March 17, 2004

Refer to: HSA-10/B-109B

Mr. Michael J. Burkett
Burkett Moulding, Incorporated
21 Hamilton Street
Monroeville, Ohio 44847

Figure 1. Summary of Results - P-Block Blockout NCHRP 350 Test 3-11

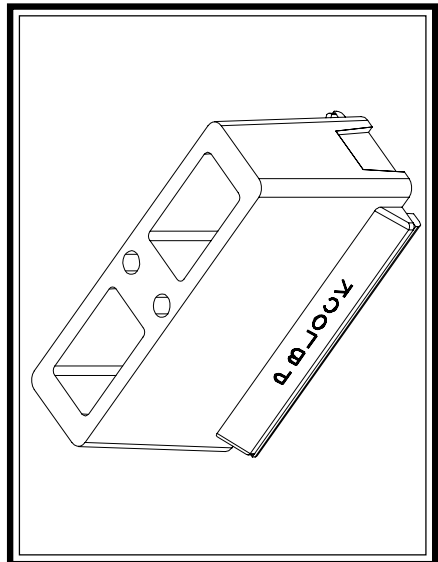
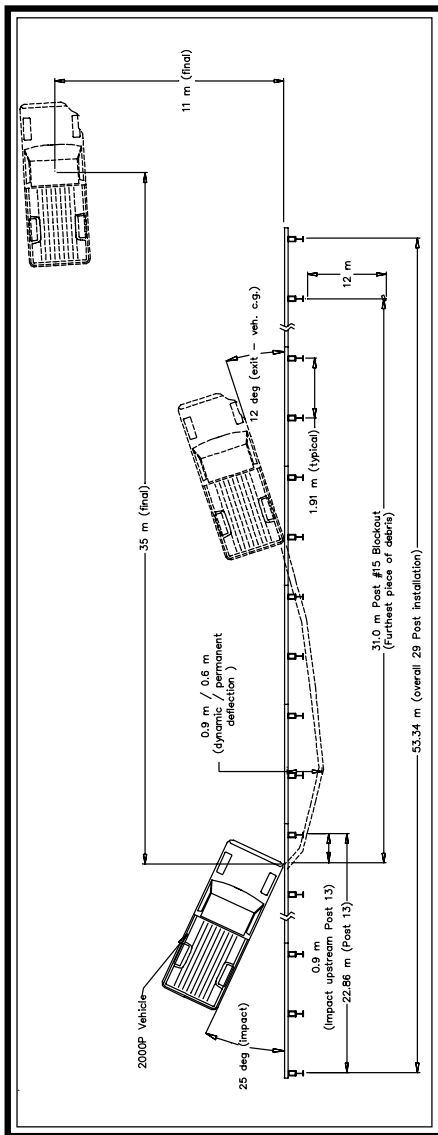
Test Agency	E-TECH Testing Services, Inc.
Test Designation	NCHRP 350 Test 3-11
Test No.	53-0017-001
Date	12/17/03
Test Article	
Type	Burkett Moulding, Inc.
Installation Length	P-Block Guardrail Blockout
Material and key elements	53.34 m Guardrail (overall)
.....	AASHTO SGR04a Guardrail with
.....	SEW02a End Terminal equipped
.....	with 152 mm x 203 mm x 354 mm
.....	3.2 kg blockouts of a 50-50 mix of
.....	LDPE/HDPE reground plastic
Foundation Type and Condition	NCHRP 350 Strong Soil, well
.....	drained
Test Vehicle	
Type	Production Model
Designation	2000P
Model	1989 Chevrolet C2500
.....	3/4 Ton Pickup
Mass (kg)	
Curb	1972
Test inertial	1995
Impact Conditions	
Speed (km/h)	99.7
Angle (deg)	25
Impact Severity (kJ)	136.6

Exit conditions	
Speed (km/h)	50.8
Angle (deg - veh. c.g.)	12
Occupant Risk Values	
Impact Velocity (m/s)	5.0
x-direction	-4.5
y-direction	
Ridedown Acceleration (g/s)	
x-direction	-8.4
y-direction	-8.9
European Committee for Normalization (CEN) Values	
THIV (km/h)	23.9
PHD (g/s)	11.3
ASI	0.7
Post-Impact Vehicular Behavior (deg - rate gyro)	
Maximum Roll Angle	-4.0
Maximum Pitch Angle	-7.0
Maximum Yaw Angle	-43.5
Test Article Deflections (m)	
Dynamic	0.9
Permanent	0.6
Vehicle Damage (Primary Impact)	
Exterior	
VDS	RFQ-3
CDC	01RFEW3
Interior	
VCDI	AS0000000
Maximum Deformation (mm)	Negligible

I agree that the modified P-Block, as described above, is acceptable for use with strong post W-beam guardrail installations on the NHS. Minor modifications to the dimensions of the P-Block for use with Thrie-beam guardrail (longer block and wings) and with round wood posts (concave backside to match the posts) are also acceptable.
